# Department of Planning, Housing, & Community Development

**Date:** 11 December 2013  
**To:** Commission on Architecture & Urban Design Members  
**Subject:** **23 Front Street – Rear Stair Addition**  
**Tax ID:** 160.55-3-9  
**Case:** CAUD 2013-43  
**Copies:** T. Costello; M. Welch; file

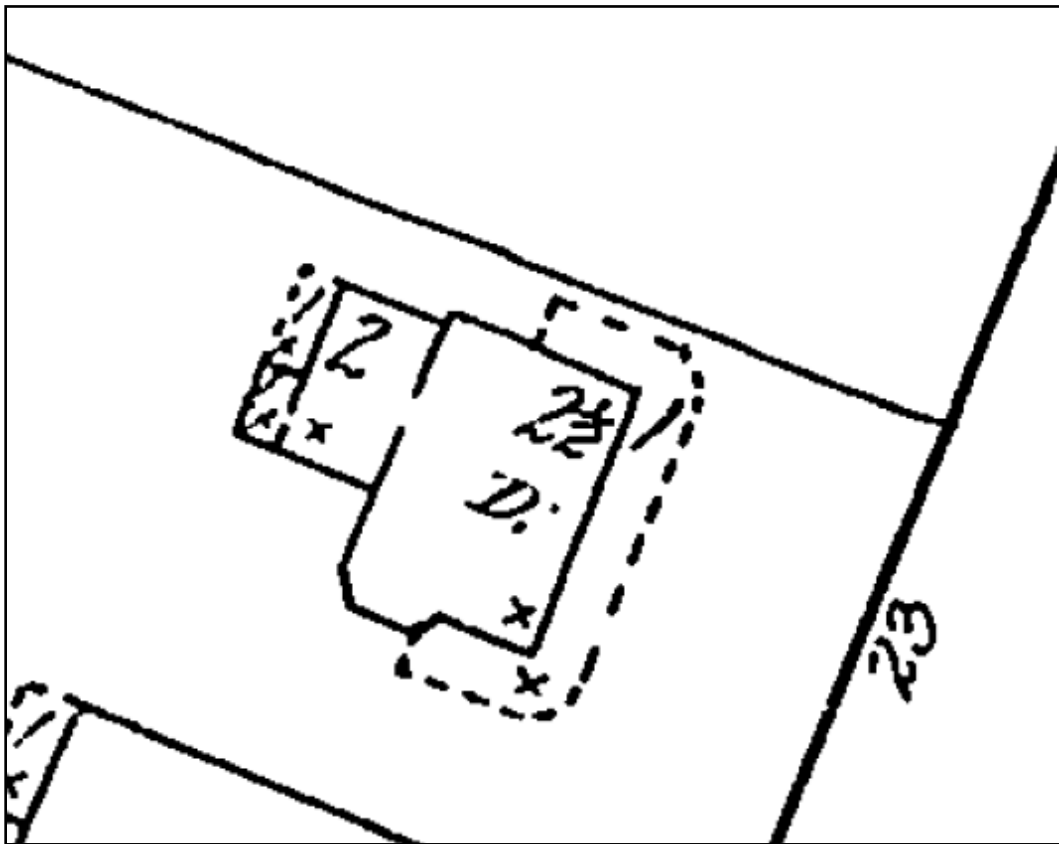
The existing rear stair can be dated to 1948, but is in a deteriorated state. Exterior stair additions can be considered acceptable on historic buildings if they meet certain criteria. The National Park Service Interpreting the Standards bulletin no. 10 addresses these additions. Typically, a new exterior stair has to

be compatible with the design and character of the building, located on a non-primary façade, and does not destroy character defining features. The addition should also be constructed such that it could be removed without destroying the essential integrity and form of the building. The proposed addition meets these requirements as it is located on the rear of the building, which is not readily visible from the public right-of-way, and is designed to reflect the style of the building. While the proposal does include removal of existing original windows, those windows are being incorporated into the addition.

Additionally, review of the Sanborn maps indicates the existing rear porch is not original to building; and that from at least 1918 through 1950, there was an enclosed addition on the rear of the structure in the approximate location of the proposed addition.
